ADDENDUM NO. 2

TO: PLANS AND SPECIFICATIONS FOR THE STATE OF MISSOURI

HVAC Improvements
Fulton Reception and Diagnostic Center
Fulton, Missouri
Project No.: C2406-01

SHEET NUMBER:
A400

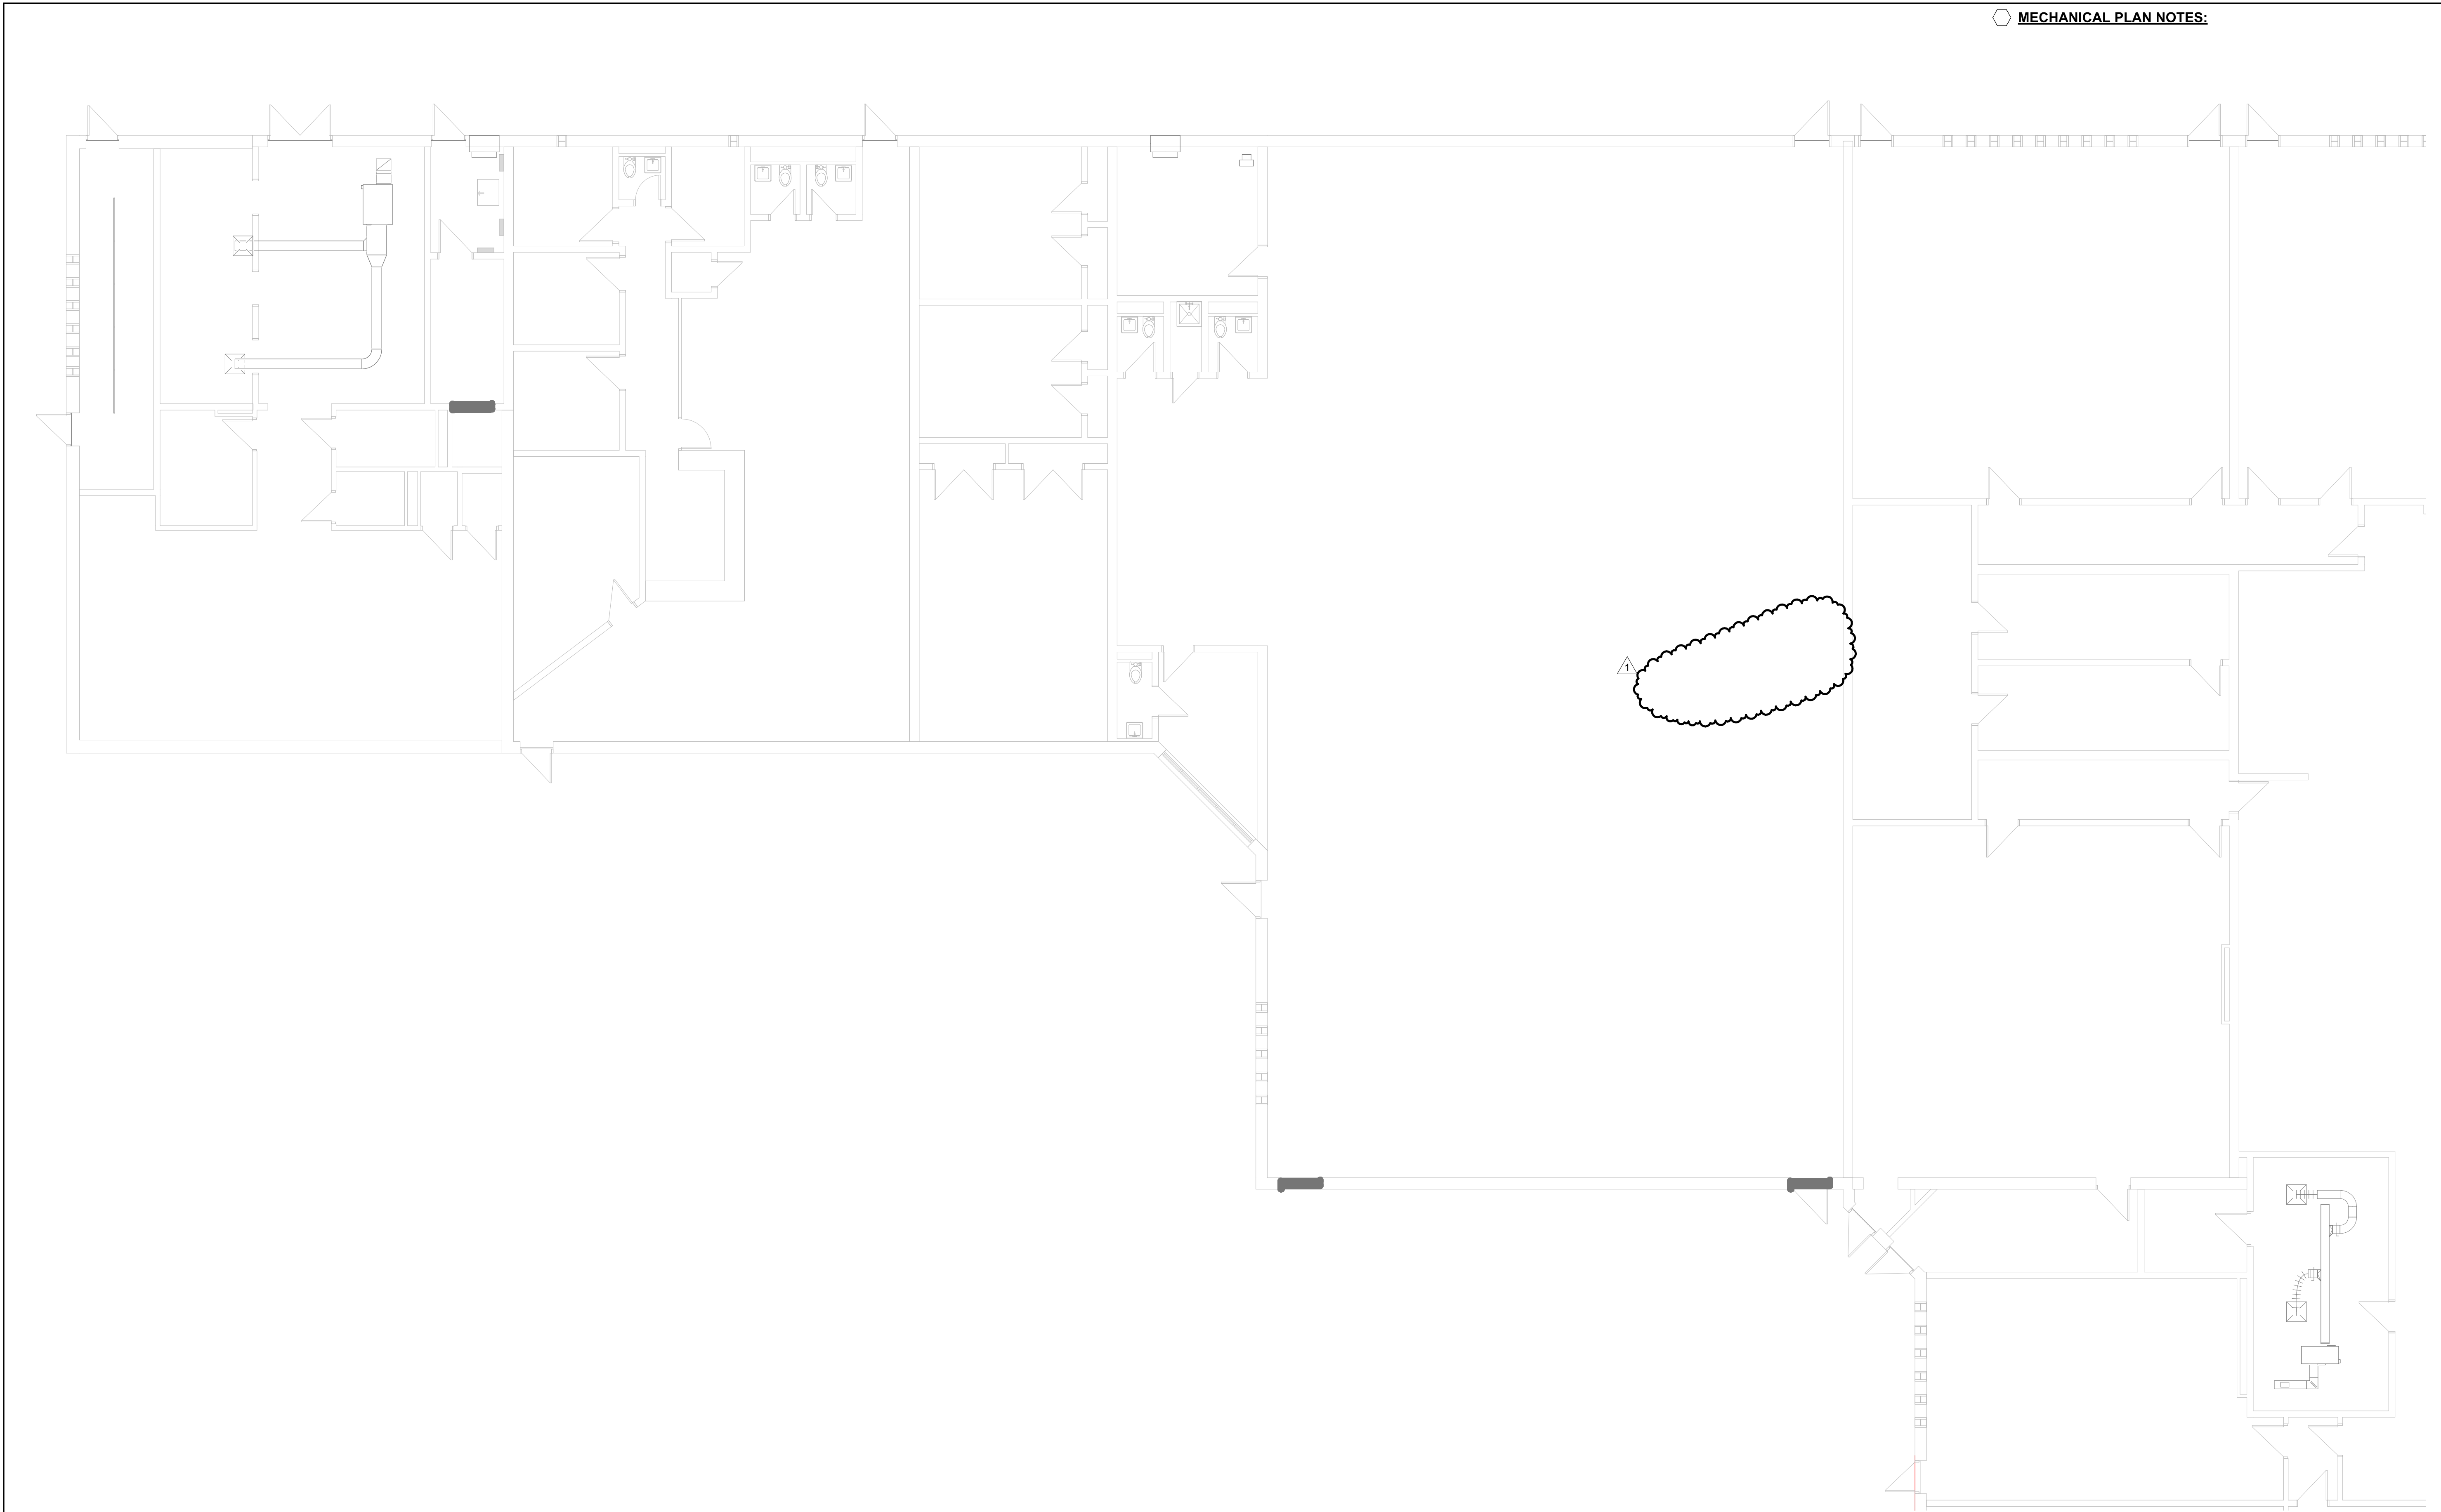
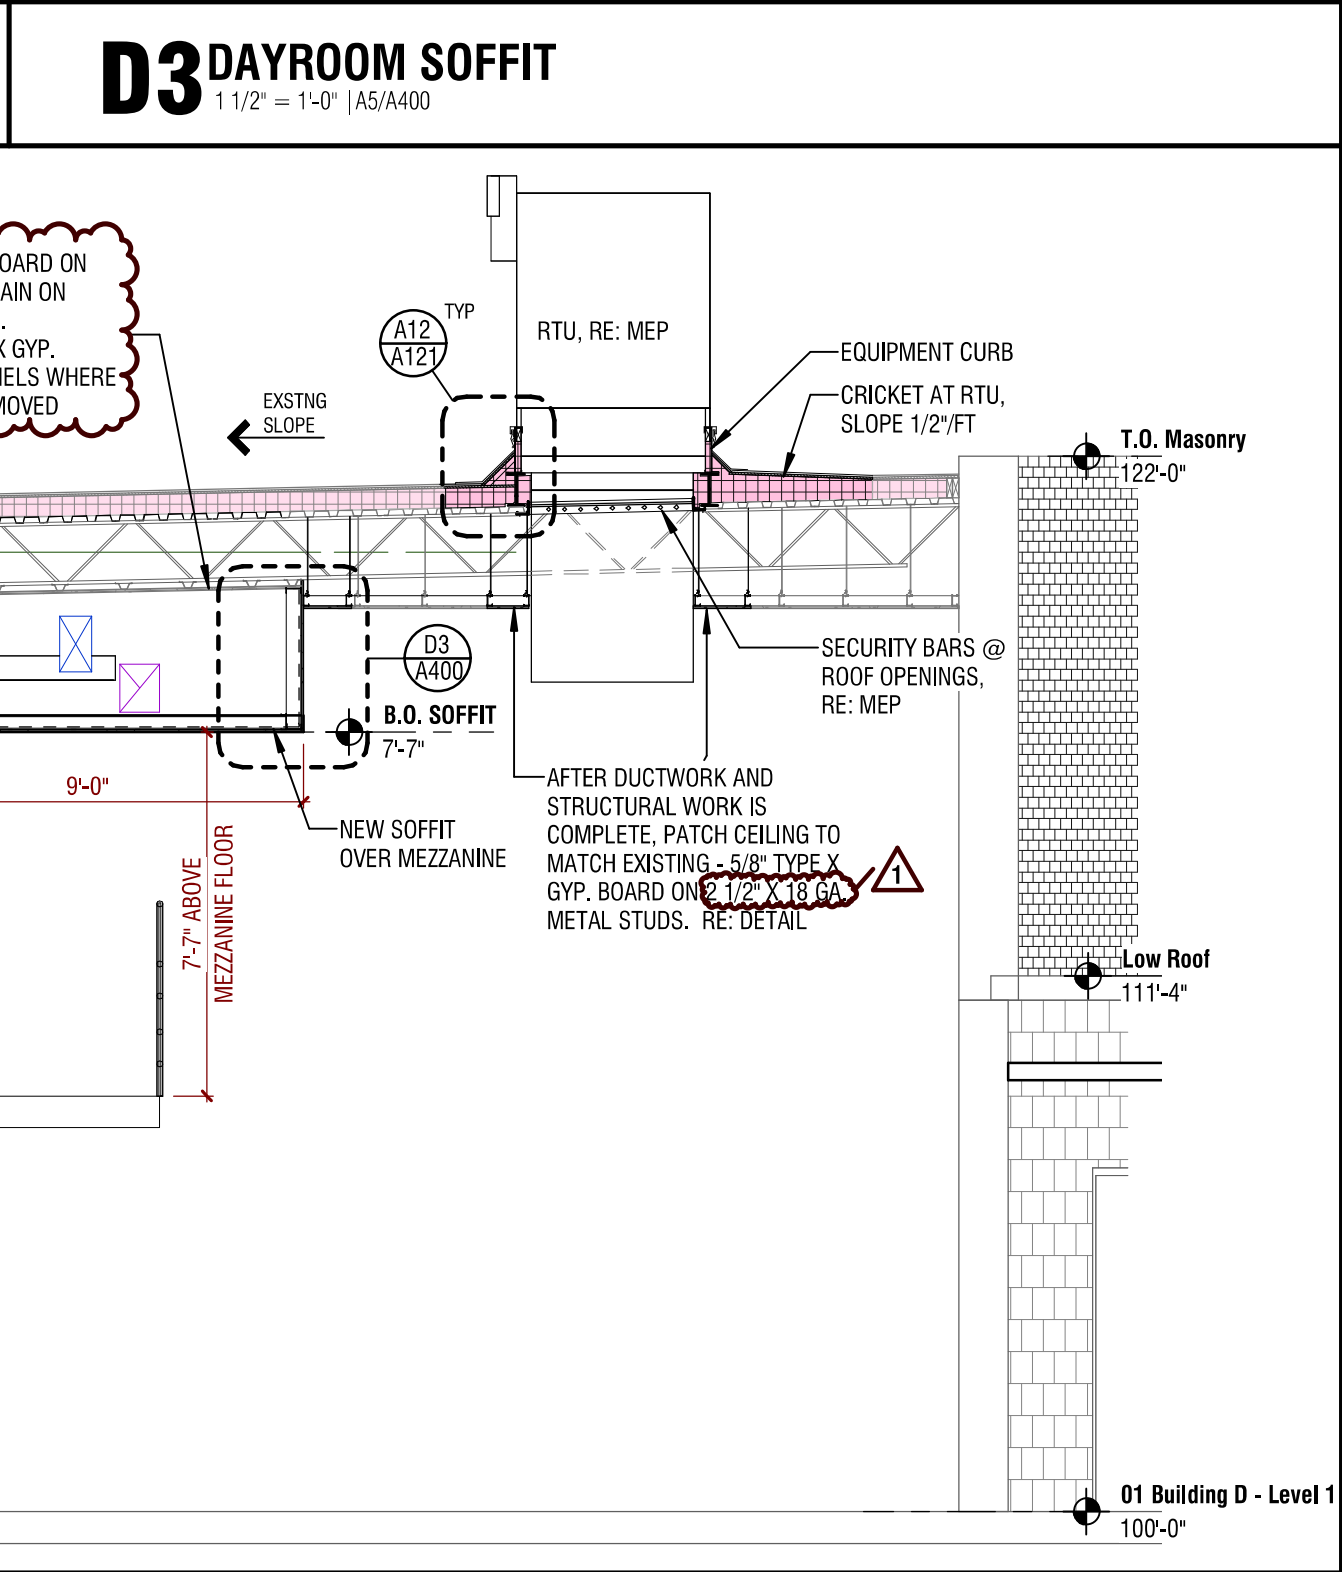
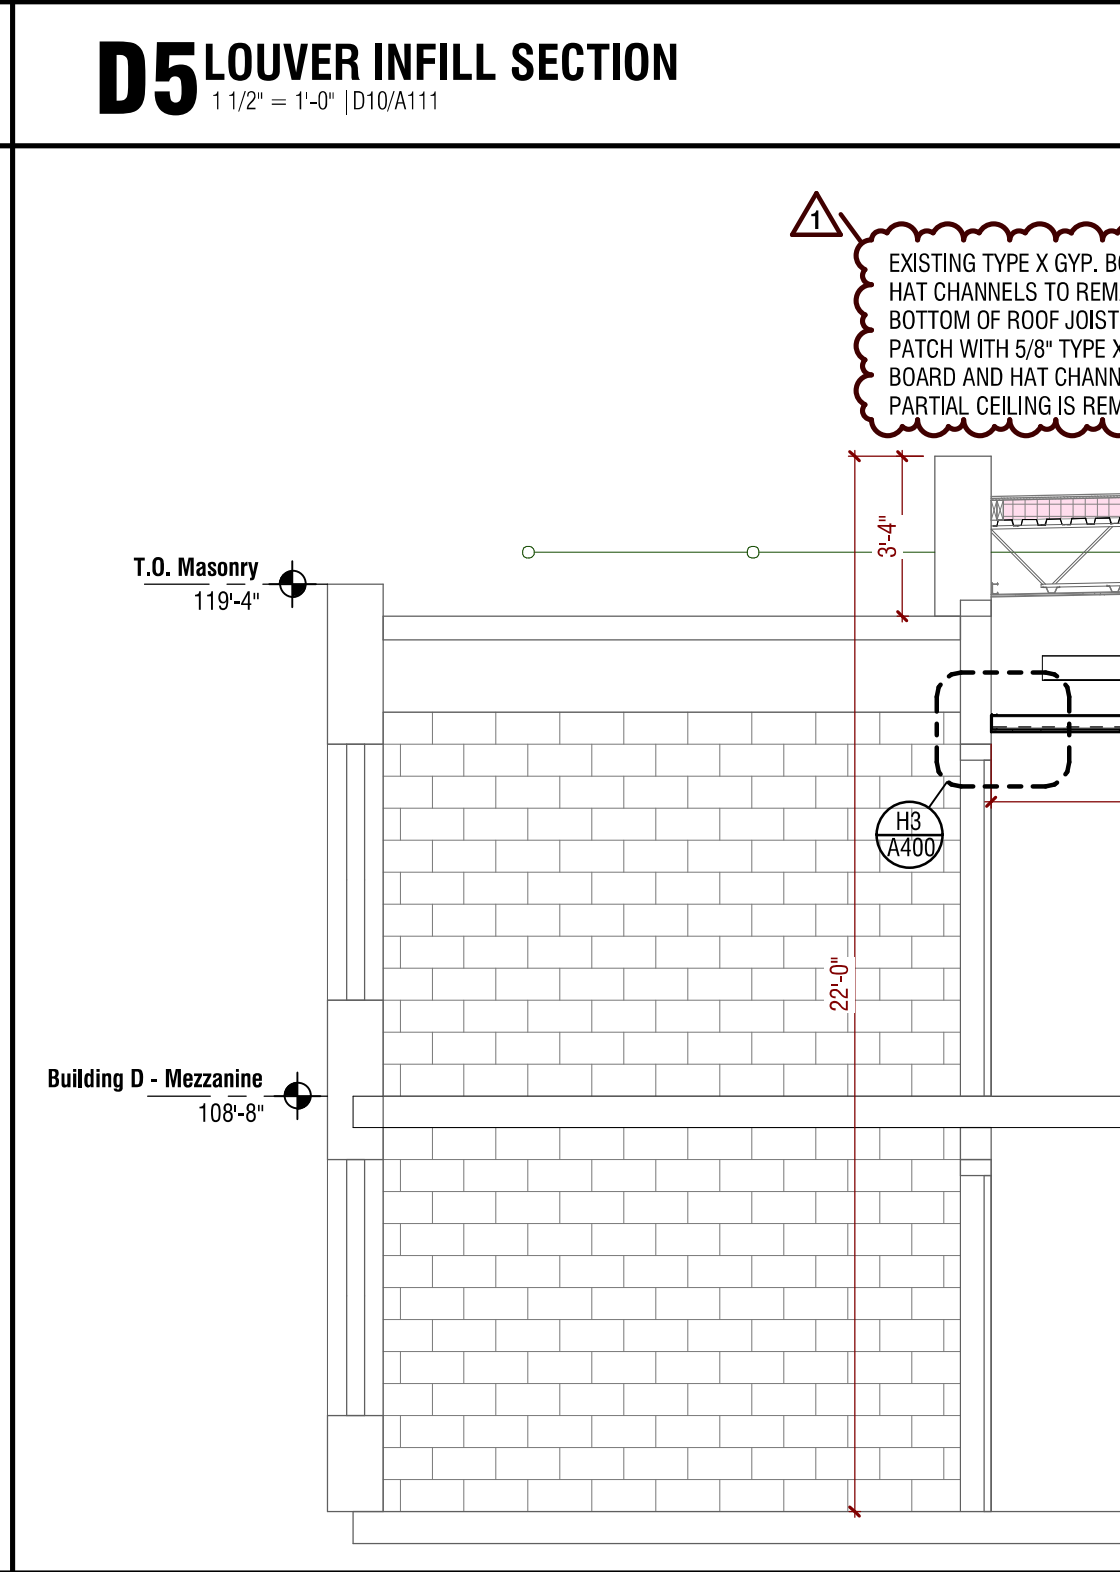
- 1) A5 and A12 Building Sections:
 - a. Revise the existing ceilings to remain.
 - b. Edited notes for existing ceilings and materials.
- 2) Detail D3 Dayroom Soffit
 - a. Edited notes for existing ceilings and materials.

11. Unit Price No. 1 remove and replace suspended g.b. ceiling and furring. Looking at A5/A400 it appears that there are two different, existing ceiling systems: one that is a suspended grid (one detail shows studs and another indicates CRC (cold rolled channels)) with abuse board above the Dayrooms and one that is a hat channel furring system with abuse board that attaches to the underside of the sloping bar joist. The question is that it appears the detail is a bit inaccurate because it shows the furring system as suspended and not attached to the underside of the bar joist. So, which is this

portion of ceiling: suspended or attached to the bar joist as a furring system as described in the Unit Price description?

Response: The existing ceilings in the dayrooms are both ceiling systems: furring channels and gyp. board directly attached to the bar joists (for smoke control) and the suspended ceilings. Sheet A400 has been revised to better reflect the existing ceiling systems and revised notes. For Unit Price #1, the ceiling system is 5/8" type X abuse-resistant gypsum board on suspended 2 1/2" x 18 ga. metal studs at 16" o.c. The patching of the existing ceiling does not include the new mezzanine soffits, which is a set quantity.

Response: Reference to revised drawing A400 for updated details and notes.
